RSA Designer Response

ROAD SAFETY AUDIT STAGE 1/2

Project Title	Llay S278
Client	Bellway/Anwyl
Curtins Job Ref No:	065665
RSA Response Ref:	065665-CUR-00-XX-RP-D-9501-V00 Llay S278 RSA 1/2 Designer Response
RSA Report Ref:	610/2019/109/01 Llay S278 RSA 1/2 (included as Appendix A)

STAGE 1/2 ROAD SAFETY AUDIT

12.1 STRAIGHT MILE

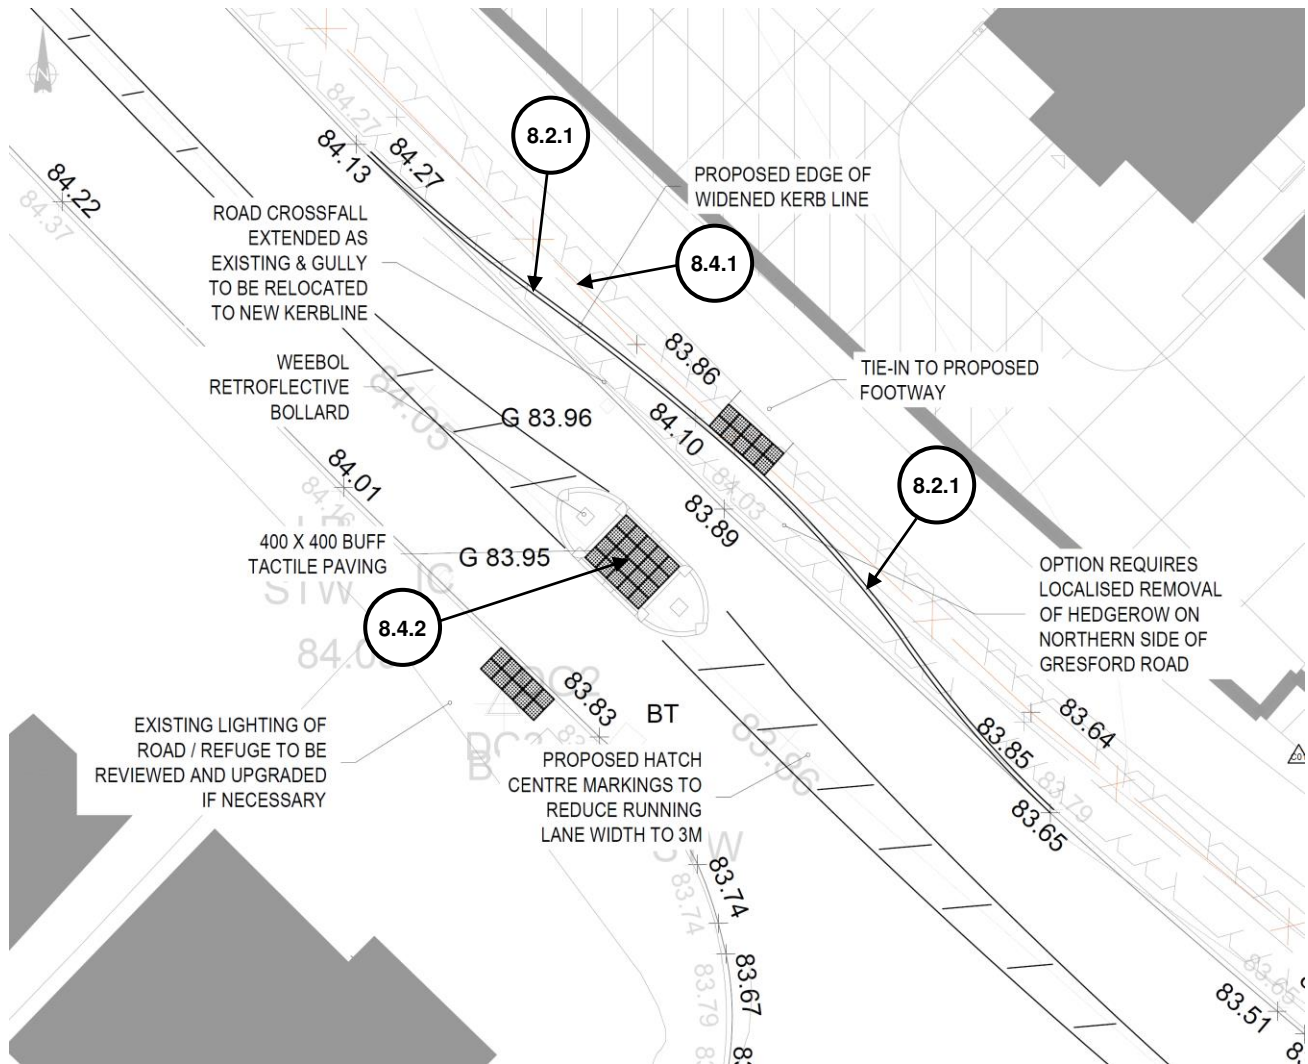
The drawing provided for audit does not show the proposed lane widths on Straight Mile through the proposed junction. If adequate lane widths are not provided for vehicles travelling through the junction or turning right, then there may be an increased risk of side swipe collisions or head-on collisions if vehicles are overhanging into the opposing traffic lanes.

It was observed during the site visit that the proposed junction is located to the west of an existing blind summit on Straight Mile. This may result in the visibility splay to the east of the junction being reduced due to the blind summit. A reduction in intervisibility at the proposed junction may increase the risk of collisions between those turning out of the access road and those travelling along Straight Mile. Additionally, this may also increase the risk of rear end shunt collisions on Straight Mile due to westbound drivers unaware of vehicles braking for the junction just over the blind summit.

The drawings provided for audit show a footway to the east of the proposed junction continuing for a short distance along Straight Mile. The provision of this length of footway may encourage pedestrians to walk east along the carriageway of Straight Mile increasing the risk of pedestrian/vehicular collisions. Additionally, there are no uncontrolled pedestrian crossing facilities provided on the proposed central refuge island to the east of the junction. This may increase the risk of pedestrian trips and falls due to the lack of dropped kerbs for those who may choose to cross at this island in order to carry on walking east along Straight Mile.

The drawings provided for audit do not show any tactile paving on the proposed pedestrian refuge island to the west of the junction. A lack of tactile paving may result in confusion for partially sighted pedestrians who may directly enter the carriageway due to the lack of contrast (visual & physical) between the refuge island and the adjacent carriageway. This may increase the risk of collisions between pedestrians and motorised vehicles at this location.

Two ahead/turn-right road marking arrows are proposed on the eastbound approach to the junction. The provision of these arrows on a single lane approach to this type of junction is non-standard. This may lead to drivers being confused assuming they need to enter the hatched area in order to turn right and they may collide with the pedestrian refuge island. It is also noted there is a lack of deflection arrows on both approaches to the hatched road markings, which could increase the risk of drivers colliding with the central islands.

The drawing provided for audit show the incorrect type of junction warning sign for this layout. The sign shown on the drawings is used where the major road continues into the side road and the minor road carries straight on. It is also noted that the incorrect diagram numbers are shown on the drawing (drawing reads 506.11, which should read 506.1). If the incorrect signs are installed there may be an increased risk of vehicular collisions at the junctions as an approaching driver may assume the major road continues into the side road and may not give way to oncoming vehicles.

The drawings provided for audit do not show any terminal speed limit signs at the junction of the proposed access road and Straight Mile. It is noted from the drawings for the Crown Crossroads that the speed limit on Straight Mile is being reduced to 40mph, and it is assumed that the access road will have a lower speed limit. If appropriate terminal speed limit signs are not provided, then vehicles may enter the access road at excessive speeds and may increase the severity of any collisions that may occur.

Problem Identified (Paragraph No)	Problem Accepted (YES/NO)	Recommendation Accepted (YES/NO/PART)	Response/Action (describe)
STRAIGHT MILE			
6.3.1 Location: Straight Mile at proposed junction Problem Summary: Possible narrow lane widths through junction The drawing provided for audit does not show the proposed lane widths on Straight Mile through the proposed junction. If adequate lane widths are not provided for vehicles travelling through the junction or turning right, then there may be an increased risk of side swipe collisions or head-on collisions if vehicles are overhanging into the opposing traffic lanes. Recommendation The lane widths should be checked to ensure they are wide enough to allow all vehicles travelling through the junction adequate space without overhanging into opposing lanes, and modifications made to the design if wider lanes are required.	N	Y	The through lane widths on Straight Mile are as existing at 3.3m. The right turn lane width is 3.5m. Dimensions to be added to relevant drawing(s). No design modifications required.

Problem Identified (Paragraph No)	Problem Accepted (YES/NO)	Recommendation Accepted (YES/NO/PART)	Response/Action (describe)
STRAIGHT MILE			
6.3.2 Location: Straight Mile at proposed junction Problem Summary: Possible reduced junction intervisibility due to existing vertical road alignment on Straight Mile It was observed during the site visit that the proposed junction is located to the west of an existing blind summit on Straight Mile. This may result in the visibility splay to the east of the junction being reduced due to the blind summit. A reduction in intervisibility at the proposed junction may increase the risk of collisions between those turning out of the access road and those travelling along Straight Mile. Additionally, this may also increase the risk of rear end shunt collisions on Straight Mile due to westbound drivers unaware of vehicles braking for the junction just over the blind summit. Recommendation The appropriate junction intervisibility splays in both the horizontal and vertical planes should be checked to ensure suitable intervisibility is provided between the proposed access and those travelling along Straight Mile. Amendments to the junction location should be carried out if appropriate intervisibility cannot be provided at its current location.	N	P	The location of the junction on Straight Mile is situated on a stretch of road that falls continuously from west to east for greater than 120 metres in each direction (as indicated by the road levels on drg. 9501). Intervisibility splays, both horizontally and vertically, comply with the requirements for a 40mph speed limit. No design modifications required.

Problem Identified (Paragraph No)	Problem Accepted (YES/NO)	Recommendation Accepted (YES/NO/PART)	Response/Action (describe)
STRAIGHT MILE			
6.4.1 Location: East of proposed junction Problem Summary: Footway may encourage pedestrians to walk along the carriageway of Straight Mile and no uncontrolled pedestrian crossing facilities provided The drawings provided for audit show a footway to the east of the proposed junction continuing for a short distance along Straight Mile. The provision of this length of footway may encourage pedestrians to walk east along the carriageway of Straight Mile increasing the risk of pedestrian/vehicular collisions. Additionally, there are no uncontrolled pedestrian crossing facilities provided on the proposed central refuge island to the east of the junction. This may increase the risk of pedestrian trips and falls due to the lack of dropped kerbs for those who may choose to cross at this island in order to carry on walking east along Straight Mile. Recommendation Uncontrolled pedestrian crossing facilities should be provided at the central refuge island to the east of the proposed junction and the footway should be terminated at this point to encourage pedestrians to cross at the island. If suitable intervisibility between pedestrians using this location to cross and drivers travelling along Straight Mile cannot be achieved (refer to 6.3.2 above) then it is recommended that the footway should be terminated at the proposed uncontrolled crossing point on the access road.	Y	P	A review by Wrexham Council has requested the removal of the central refuge islands entirely. Crossing locations from the development footways across Straight Mile onto the existing footway to the north are to be relocated further west and east beyond the extents of the junction widening. Design to be amended.

Problem Identified (Paragraph No)	Problem Accepted (YES/NO)	Recommendation Accepted (YES/NO/PART)	Response/Action (describe)
STRAIGHT MILE			
6.4.2 Location: West of proposed junction Problem Summary: Lack of tactile paving on central pedestrian refuge The drawings provided for audit do not show any tactile paving on the proposed pedestrian refuge island to the west of the junction. A lack of tactile paving may result in confusion for partially sighted pedestrians who may directly enter the carriageway due to the lack of contrast (visual & physical) between the refuge island and the adjacent carriageway. This may increase the risk of collisions between pedestrians and motorised vehicles at this location. Recommendation Appropriate tactile paving should be provided on the pedestrian refuge island to the west of the proposed junction.	Y	P	A review by Wrexham Council has requested the removal of the central refuge islands entirely. Crossing locations from the development footways across Straight Mile onto the existing footway to the north are to be relocated further west and east beyond the extents of the junction widening. Design to be amended.

6.5.1 Location: Eastbound approach to proposed junction Problem Summary: Non-standard arrow road marking layout may result in driver confusion Two ahead/turn-right road marking arrows are proposed on the eastbound approach to the junction. The provision of these arrows on a single lane approach to this type of junction is non-standard. This may lead to drivers being confused assuming they need to enter the hatched area in order to turn right and they may collide with the pedestrian refuge island. It is also noted there is a lack of deflection arrows on both approaches to the hatched road markings, which could increase the risk of drivers colliding with the central islands. Recommendation	Y	Y	Design to be amended.

6.5.2 Location: Both approaches to proposed junction Problem Summary: Incorrect junction warning sign shown on drawing The drawing provided for audit show the incorrect type of junction warning sign for this layout. The sign shown on the drawings is used where the major road continues into the side road and the minor road carries straight on. It is also noted that the incorrect diagram numbers are shown on the drawing (drawing reads 506.11, which should read 506.1). If the incorrect signs are installed there may be an increased risk of vehicular collisions at the junctions as an approaching driver may assume the major road continues into the side road and may not give way to oncoming vehicles. Recommendation The drawing should be amended to show the standard junction warning sign and the diagram number should be amended to read 506.1.	Y	Y	Diagram number 506.11 is a typographical error resulting in the incorrect diagram being inserted. Warning sign and diagram number should read 506.1. Design to be amended.

6.5.3 Location: Junction of proposed access road and Straight Mile Problem Summary: Lack of terminal speed limit signs The drawings provided for audit do not show any terminal speed limit signs at the junction of the proposed access road and Straight Mile. It is noted from the drawings for the Crown Crossroads that the speed limit on Straight Mile is being reduced to 40mph, and it is assumed that the	Y	P	Terminal speed limit signs not currently shown on S278 drawings as crossover to S38 design being prepared by another consultant. Signs will be added for completeness with note relating to coordination with S38 design on location. Design to be amended.

12.2 GRESFORD ROAD PUFFIN

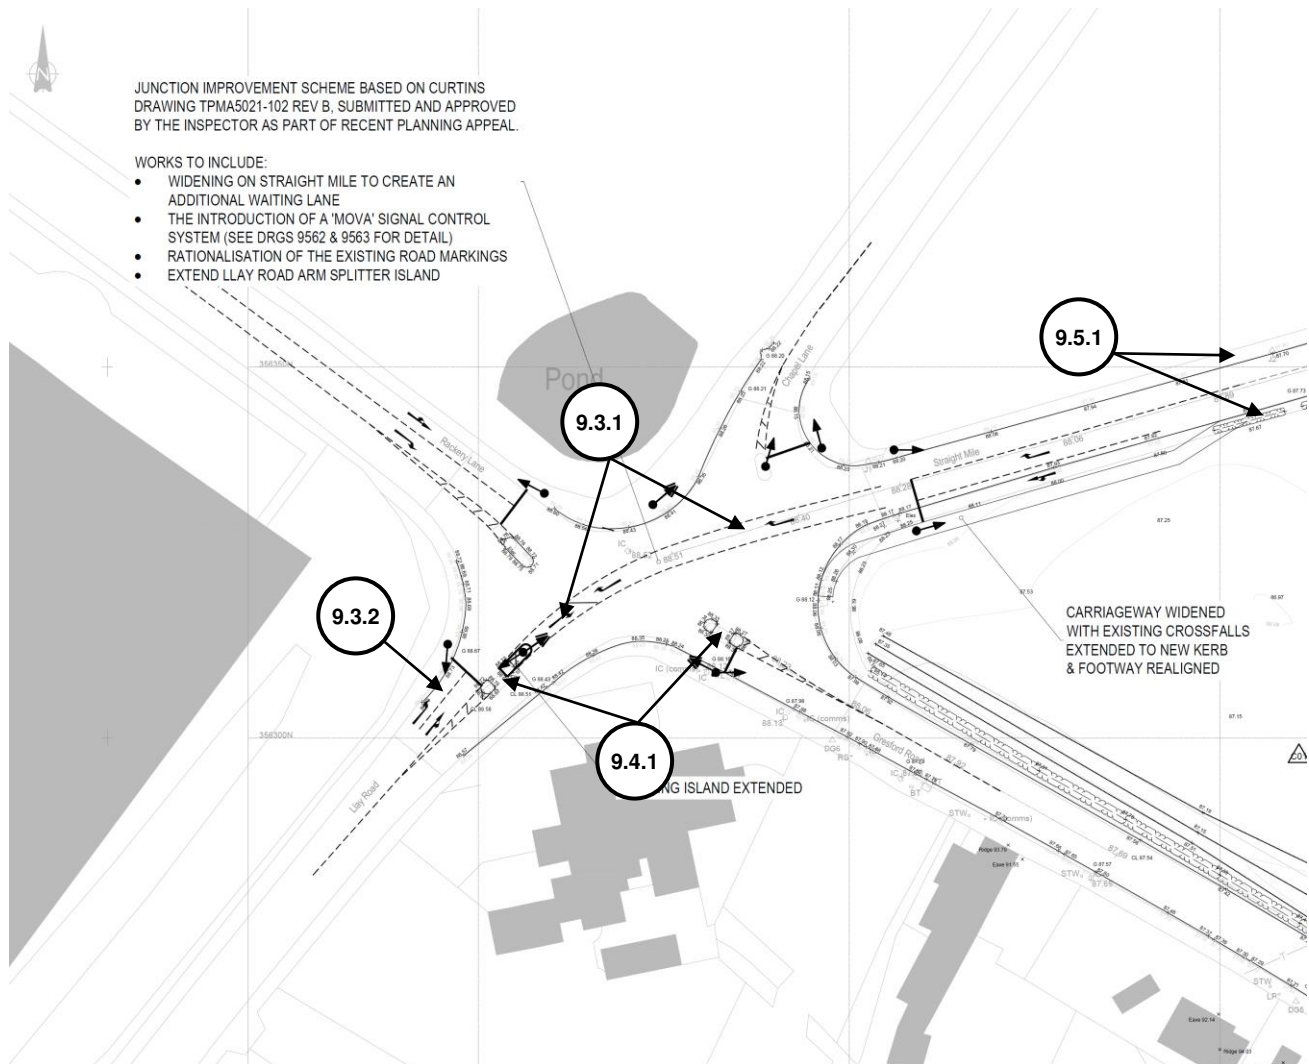
It was observed during the site visit that the intervisibility between north-westbound drivers approaching the Puffin crossing and pedestrians crossing from the south-western footway appears to be reduced due to the left-hand bend on the approach to the proposed Puffin crossing. This may increase the risk of collisions between these pedestrians and vehicles travelling north-west. (Photo 13.1 & 13.2)

The drawings show that the proposed length of high friction surfacing (HFS) on both approaches to the proposed Puffin crossing is 12.8m and the HFS does not continue to the crossing studs. This length of HFS is insufficient for the approach speeds and may result in skid type collisions including rear-end shunts and collisions between pedestrians using the crossing and approaching vehicles.

It is unclear from the drawings provided for audit as to the extents of the hedgerow removal on the north-eastern side of Gresford Road. If an appropriate length of hedgerow is not removed, then the intervisibility between drivers travelling south-eastbound towards the Puffin crossing and pedestrians crossing from the north-eastern footway may be reduced. This may increase the risk of collisions between pedestrians and vehicles at the Puffin crossing.

The proposed position of the signal pole (2) located almost in the centre of the south-western footway to the southeast side of the tactile paving reduces the available footway width. The reduced footway width may result in pedestrians colliding with the signal pole, with this issue especially apparent for visually impaired pedestrians. Additionally, the proposed location of the signal pole will create manoeuvrability issues for those with pushchairs, wheelchairs and mobility scooters, who may need to enter the carriageway in order to continue their journey. This will increase the risk of collisions between these users and passing motorised vehicles.

7.1.1 Location: North-westbound approach to proposed Puffin crossing Problem Summary: Reduced intervisibility between approaching drivers and pedestrians crossing from south-western footway It was observed during the site visit that the intervisibility between north-westbound drivers approaching the Puffin crossing and pedestrians crossing from the south-western footway appears to be reduced due to the left-hand bend on the approach to the proposed Puffin crossing. This may increase the risk of collisions between these pedestrians and vehicles travelling north-west. (Photo 13.1 & 13.2) Recommendation	Y	P	The location for the Puffin crossing was selected to be as close as practicable to future pedestrian desire lines whilst trying to accommodate the existing constraints imposed by junction locations. From a point 1m from the road centre line to a point offset 0.5m from kerb face at the centre of the south-west crossing, direct intervisibility is slightly substandard at 40m. However, the design has included for a primary signal on the north-east crossing that north-westbound drivers have visibility of way in excess of 43m. This accompanied with advanced warning signage of new road layout/signalised crossing will mitigate the risk of collisions. Drawing to include intervisibility splay(s).

7.1.2 Location: Both approaches to proposed Puffin crossing Problem Summary: Reduced length of anti-skid surfacing The drawings show that the proposed length of high friction surfacing (HFS) on both approaches to the proposed Puffin crossing is 12.8m and the HFS does not continue to the crossing studs. This length of HFS is insufficient for the approach speeds and may result in skid type collisions including rear-end shunts and collisions between pedestrians using the crossing and approaching vehicles. Recommendation The proposed high friction surfacing on both approaches should be extended for an appropriate distance taking into account the approach speeds and should also be extended to the crossing studs.	Y	P	A review by Wrexham Council has requested the removal of the high friction surfacing entirely due to maintenance issues. They have requested that the carriageway approach is resurfaced 50m either side of the crossing location with a new 65PSV surface course. Design to be amended.

7.4.1 Location: South-eastbound approach to proposed Puffin crossing Problem Summary: Hedgerow may obscure intervisibility between south-eastbound drivers and pedestrians crossing from north-eastern footway It is unclear from the drawings provided for audit as to the extents of the hedgerow removal on the north-eastern side of Gresford Road. If an appropriate length of hedgerow is not removed, then the intervisibility between drivers travelling south-eastbound towards the Puffin crossing and pedestrians crossing from the north-eastern footway may be	Y	Y	All hedgerow in this location is to be removed. Drawings to be updated to clarify.

7.4.2 Location: Southeast side of proposed tactile paving on south-western footway Problem Summary: Reduced footway width due to location of proposed traffic signal pole (2) The proposed position of the signal pole (2) located almost in the centre of the south-western footway to the southeast side of the tactile paving reduces the available footway width. The reduced footway width may result in pedestrians colliding with the signal pole, with this issue especially apparent for visually impaired pedestrians. Additionally, the proposed location of the signal pole will create manoeuvrability issues for those with pushchairs, wheelchairs and mobility scooters, who may need to enter the carriageway in order to continue their journey. This will increase the risk of collisions between these users and passing motorised vehicles. Recommendation The signal pole (2) should be relocated nearer to the carriageway, in order to maximise available footway width, noting that sufficient clearance should be maintained between the signals and the edge of the carriageway.	Y	Y	Signal pole to be offset 0.5m from kerb face. Design to be amended.
